# LESSONS LEARNED

## SUMMARY REPORT

### Florida Turnpike Enterprise

### 1) Plan Scale and Legends – Indicating Pavement Construction:

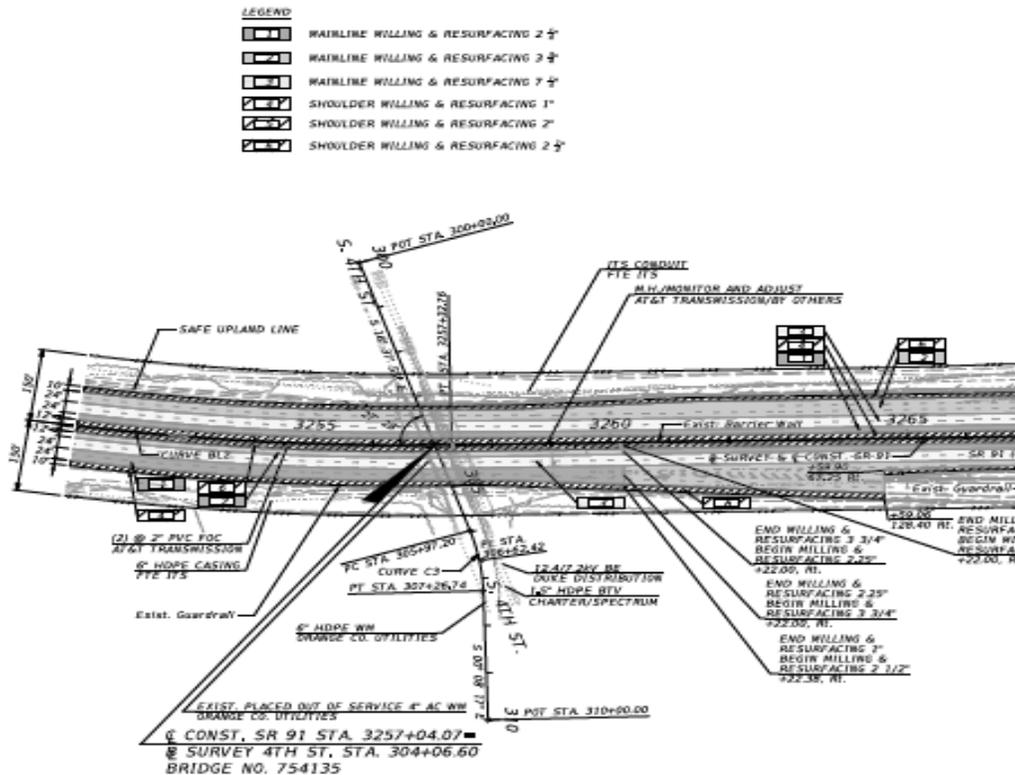
**ISSUE SUMMARY:** There is substantial information on each page, so when the scale is small, the Plan Views are more difficult to read. The legends are very helpful, but with just the variance of shading it is difficult to determine the limit of each area. The Contractor made various errors in milling and placement which had to be corrected at their cost.

**RECOMMENDATION:** Recommend providing a more definitive set of Plans for resurfacing/reconstruction of the roadway by providing more distinctive legends and delineation of milling and resurfacing areas, especially with the number of varying depths of resurfacing. The Contractor will be more likely to mill and resurface without having to go back and make corrections.

**RESOLUTION:** The CEI reviewed areas to determine if placement was incorrect due to the Plans or the Contractor’s misreading of the Plans and requested the Contractor to make corrections.

### 4) Mitigating Base Failures

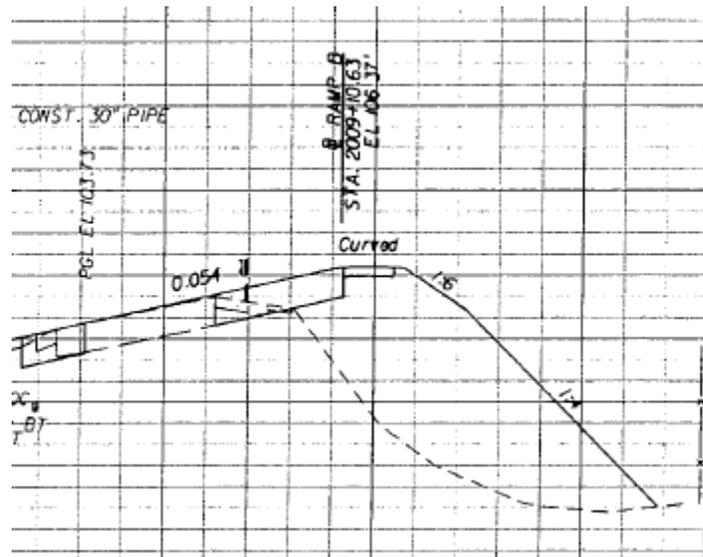
**ISSUE SUMMARY:** Due to having three (3) base failures within six (6) weeks of starting the deep milling, it was determined that the Plans would be revised to help mitigated the base failures for the remainder of the project.

**RECOMMENDATION:** During design have a discussion regarding mitigation of potential base failures. Some areas within the Turnpike system, mitigation may be achievable by performing 24 hr. lane closures providing necessary cooling times; other areas with high volume traffic, utilizing 4" of #57 stone method may be best. Consideration could be made to avoid paving directly on the base by treating the cracking (ARMI) and placing more asphalt than is removed. It is recommended to include a mitigation plan to implement whether it is to handle base failures that may occur or the prevention thereof.

**RESOLUTION:** Due to heavy daytime traffic, significantly extending the lane closure time to allow for additional cooling was not feasible. Therefore, a mitigation strategy was employed at the areas that were determined to be the greatest areas of concern. That strategy included an additional 4" of material to be removed in the deep mill areas, followed by the placement of geotextile fabric and 4" of # 57 stone. Finally, asphalt was placed in accordance with the Plans. Deep mill areas which were not determined to be the greatest area of concern were not deep milled; therefore, did not get the structural value intended for this reconstruction of the roadway. Also, with the placement of the #57 stone, drainage was provided to assure the stone areas did not hold water. These trench drains were composed of #57 stone placed on top of geotextile fabric from the outside edge of the excavated area to the outside of the shoulder and at specified locations, this included a perforated pipe so flow would be directed into a drainage structure. *Note: There were no additional base failures on the project once this Plan change was implemented utilizing the #57 stone. There were also no other contract changes as to implementing cooling time requirements or restrictions as to when to perform paving operations.*
